Simplified View of NOGRR245 Redlines from the 4/23/24 Board Report as Requested at the 5/10/24 Workshop

Figure 1: Default Voltage Ride-Through Boundaries for IRRs and ESRs Connected to the ERCOT Transmission Grid

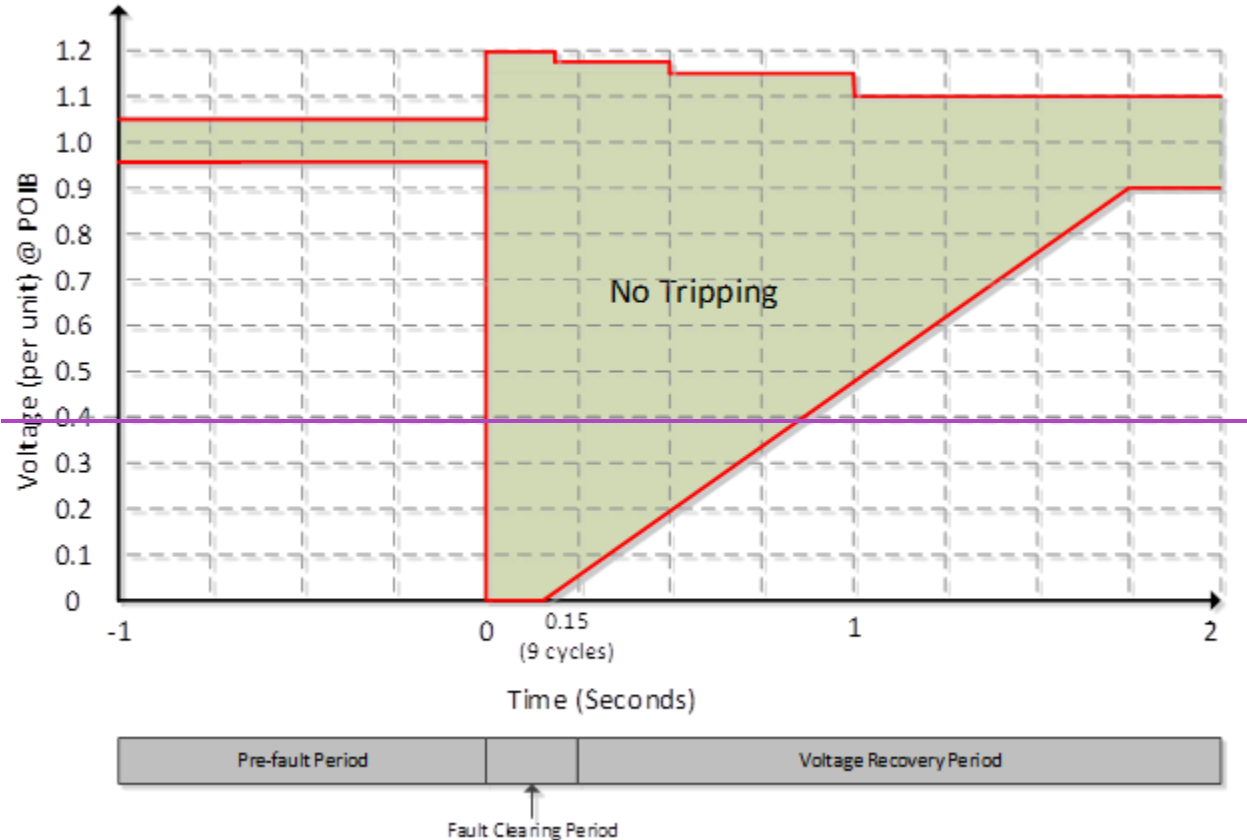
- ~~(3) Each IRR or ESR is required to set its voltage relays to remain in service for at least 0.15 seconds during all transmission faults and to allow the system to recover as illustrated in Figure 1, Default Voltage Ride Through Boundaries for IRRs and ESRs Connected to the ERCOT Transmission Grid, below. Recovery time to 90% of per unit voltage should be within 1.75 seconds. Faults on individual phases with delayed clearing (zone 2) may result in phase voltages outside this boundary but if the phase voltages remain inside this boundary, then Resource voltage relays are required to be set to remain connected and recover as illustrated in Figure 1.~~

- ~~(5) Each IRR or ESR shall set its voltage relays to remain interconnected to the ERCOT System during the following high voltage conditions, as illustrated in Figure 1: any per-unit voltage equal to or greater than 1.175 but less than 1.2 for up to 0.2 seconds, any per-unit voltage equal to or greater than 1.15 but less than 1.175 per unit voltage for up to 0.5 seconds, and any per-unit voltage equal to or greater than 1.1 but less than 1.15 for up to 1.0 seconds. The indicated voltages are measured at the POIB.~~
